**TOWN OF BAY HARBOR ISLANDS
MORRIS N. BROAD COMMUNITY CENTER
1175 95TH STREET
BAY HARBOR ISLANDS, FL 33154**

DEVELOPMENT & REVIEW COMMITTEE MEETING

**TOWN OF BAY HARBOR ISLANDS
COMMUNITY DEVELOPMENT
MEMORANDUM**

Subject: Site Development Plan Application
1085 Townhouses – 6 DU Townhouse Complex
1085 94th Street
Bay Harbor Islands Acct. No. SPR24-000025
MMPA Account No. 01-0702-1197

WEST ELEVATION (BAY HARBOR TERRACE)

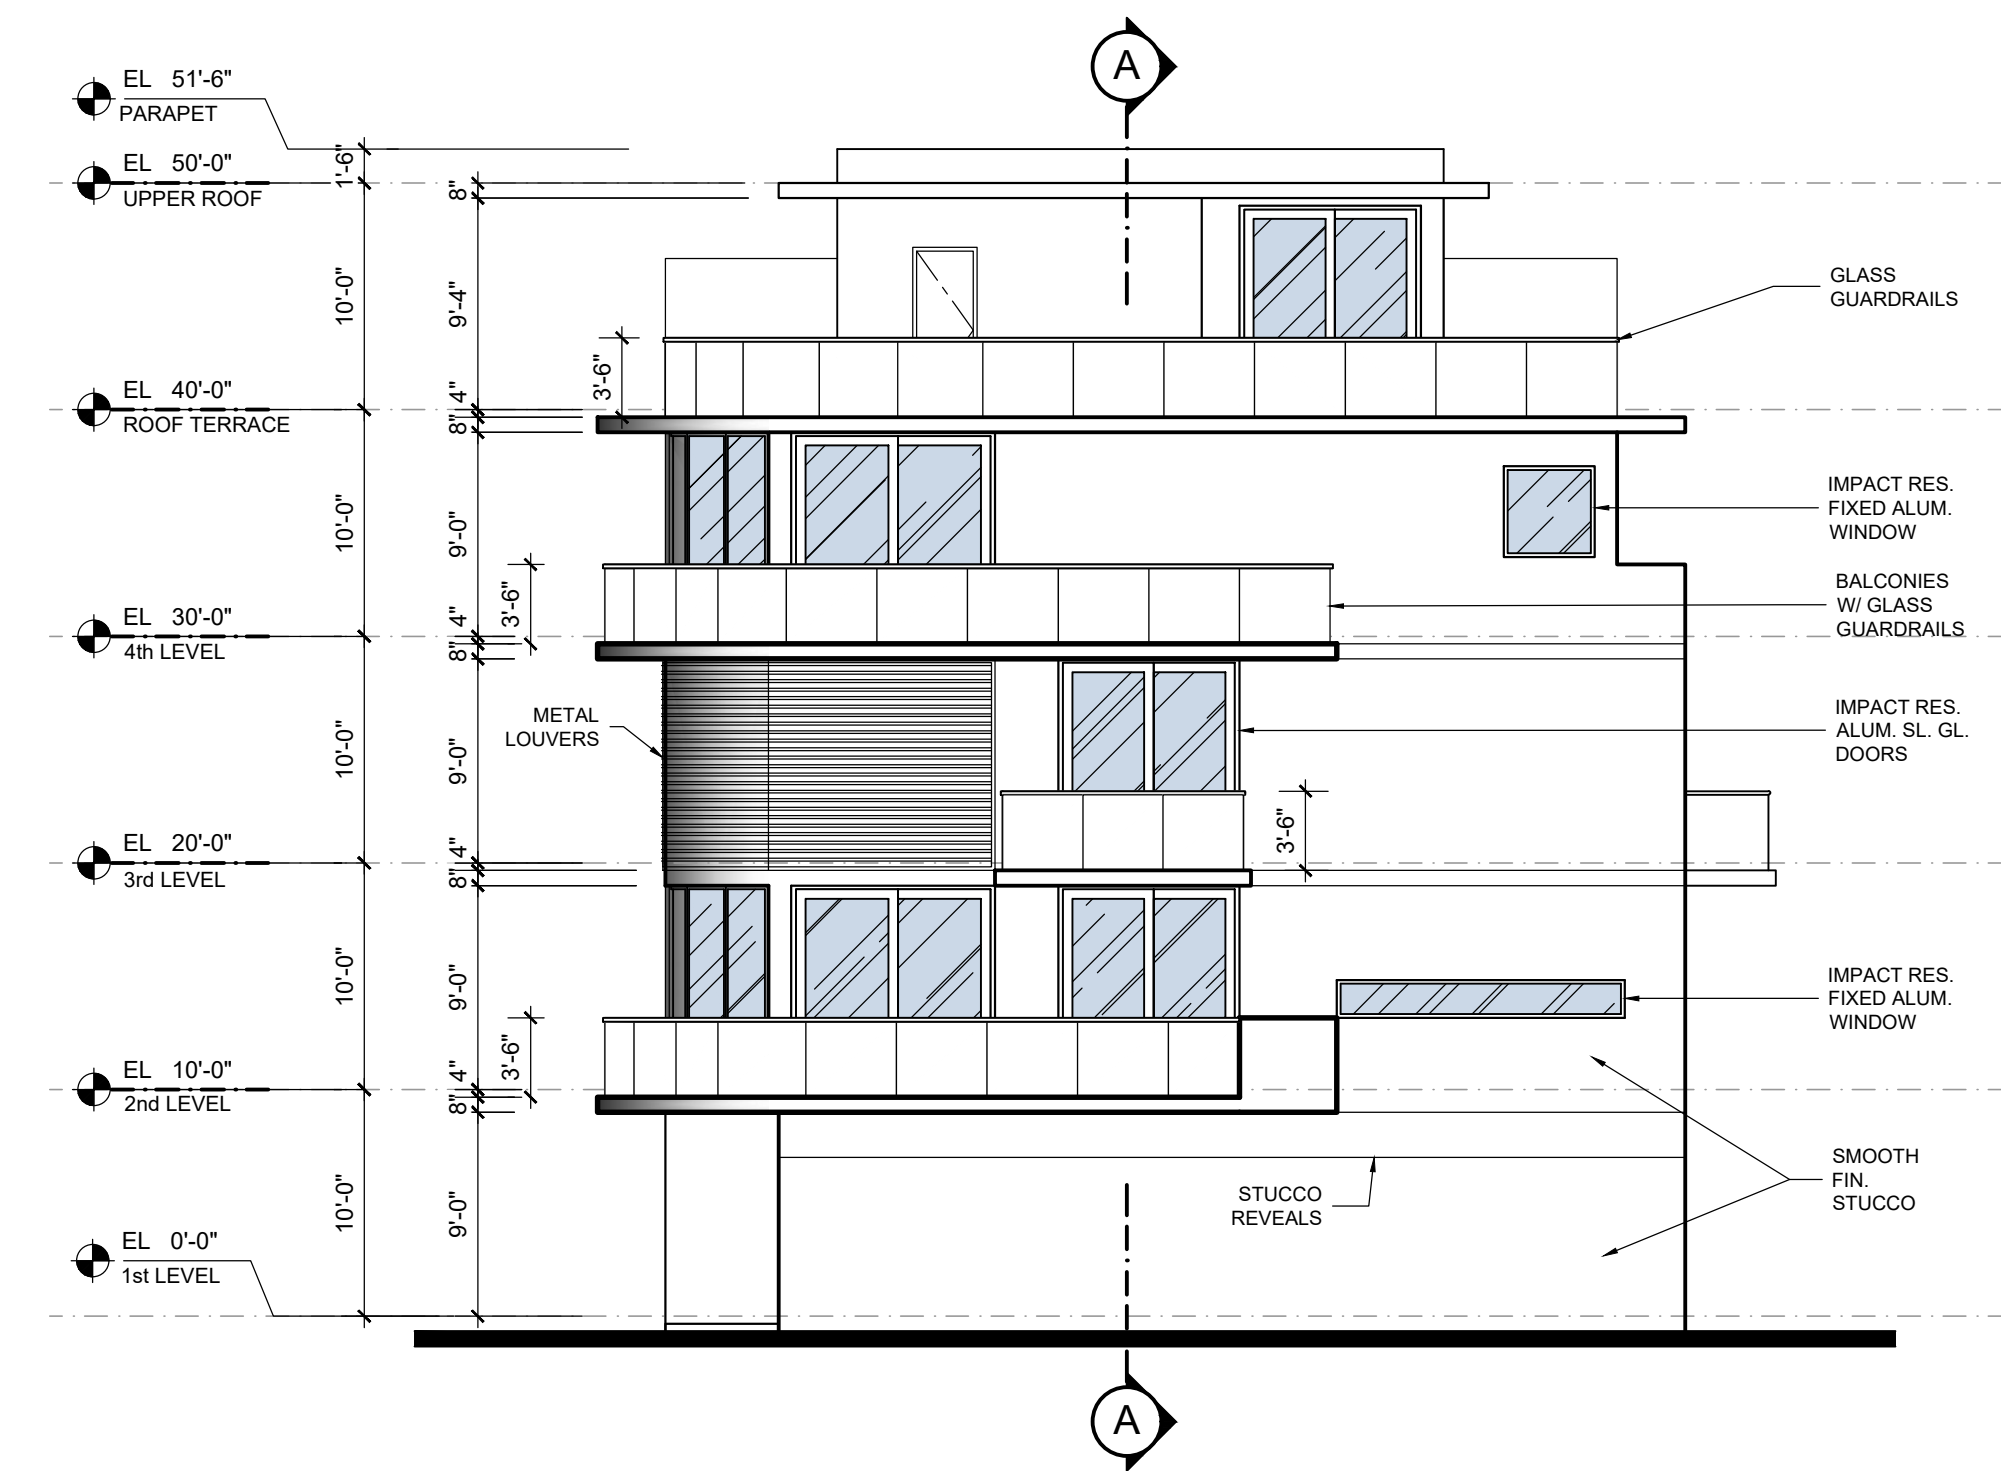
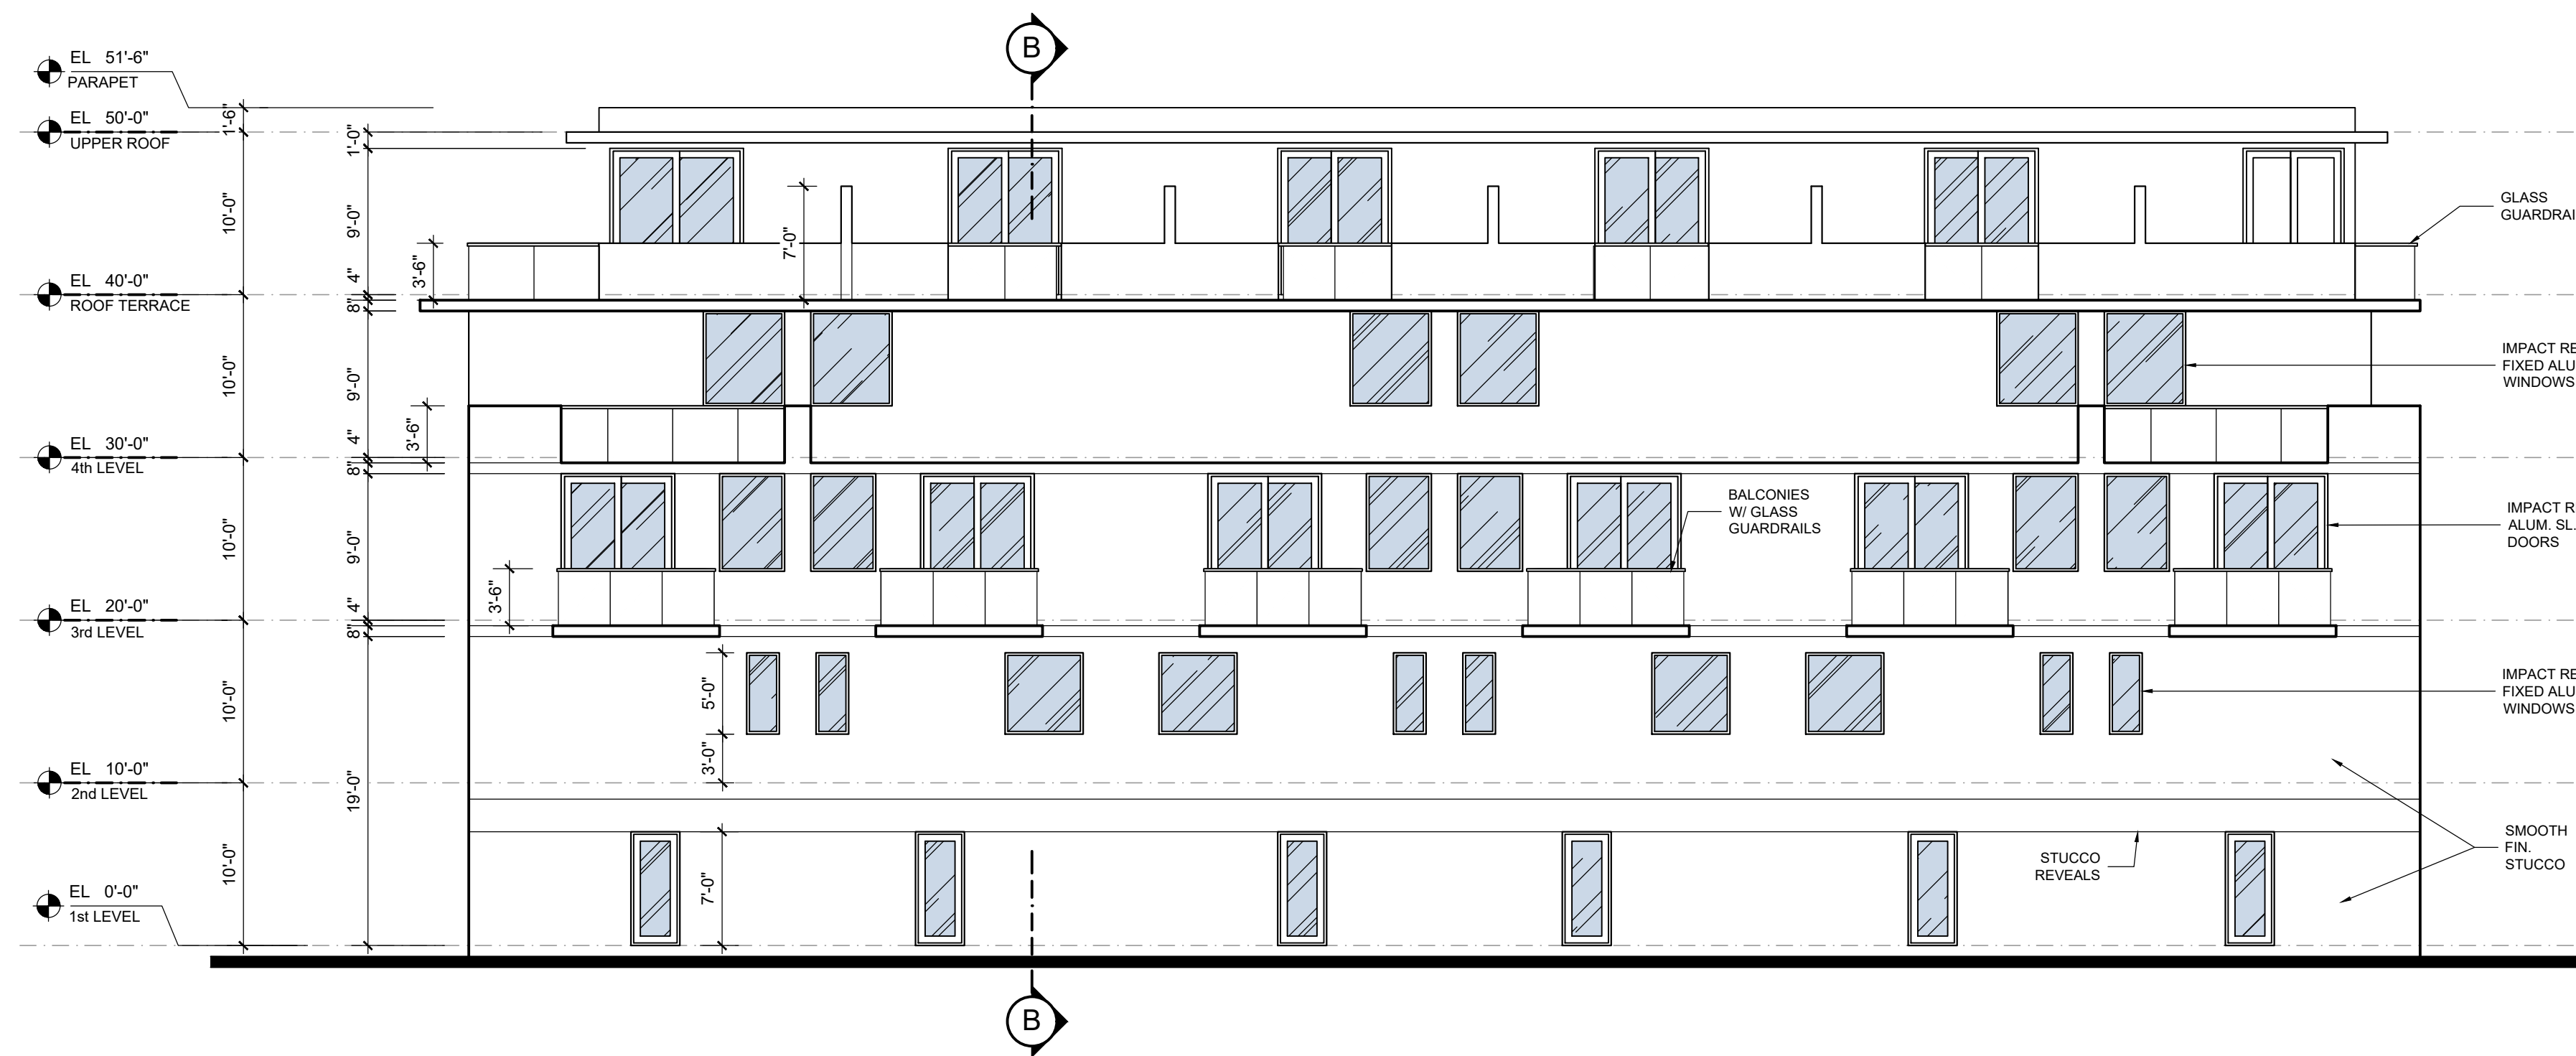
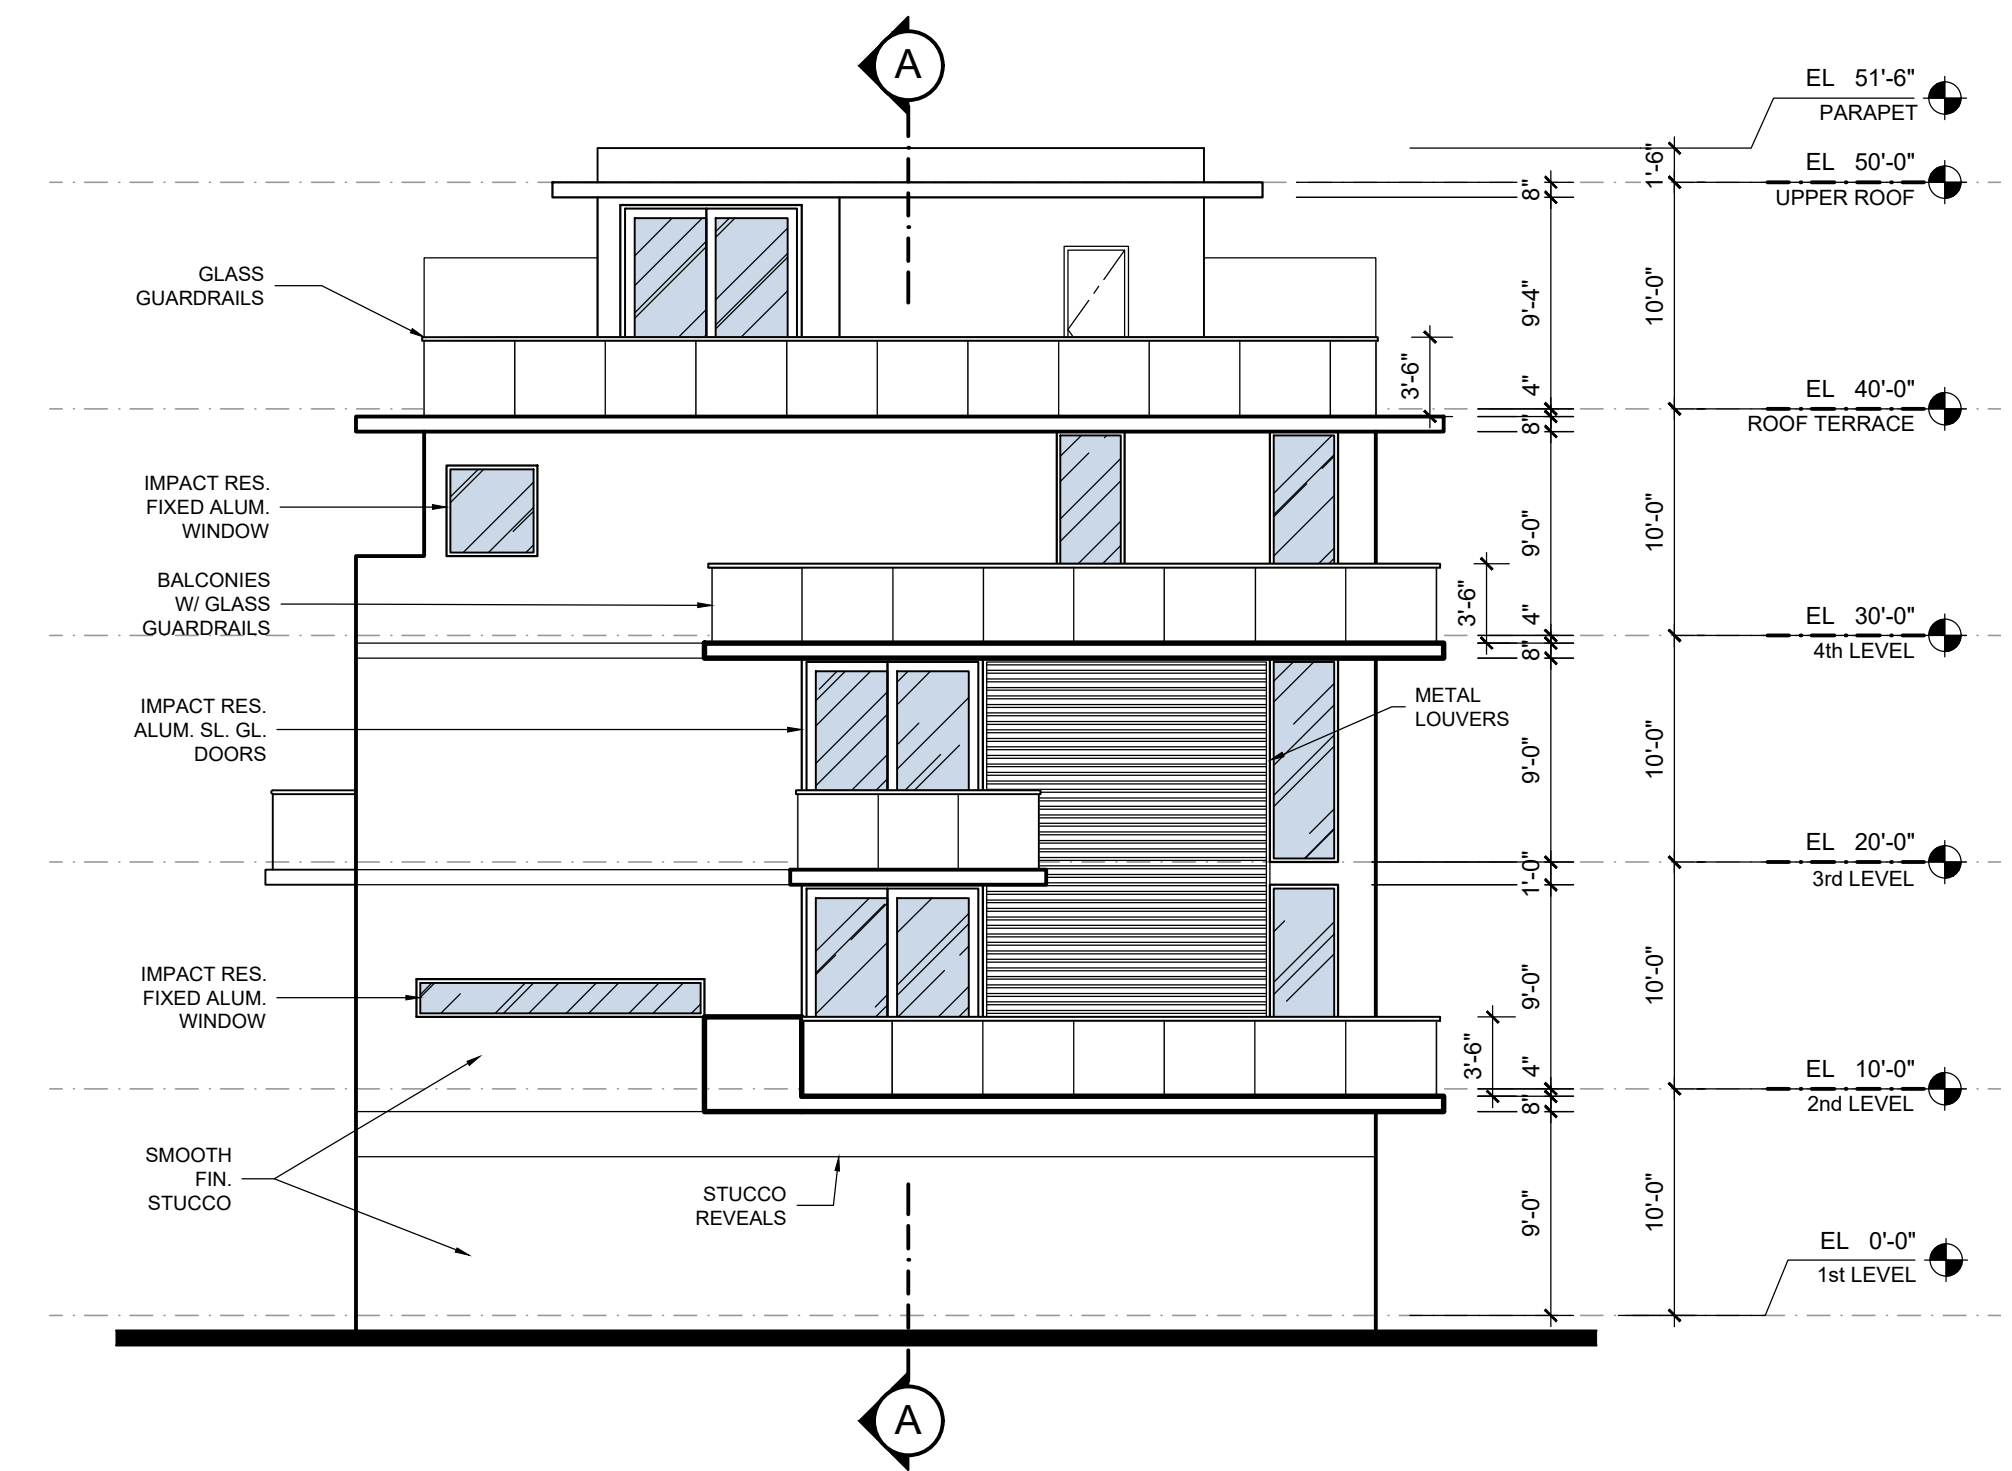
- 2) All elevation plans must label the Base Flood Elevation (BFE) + 1' FBC freeboard for each building elevation.
- 3) Elevation Sheet A-3 / others does not scale to 1/8" = 1'-0". Please check and revise.
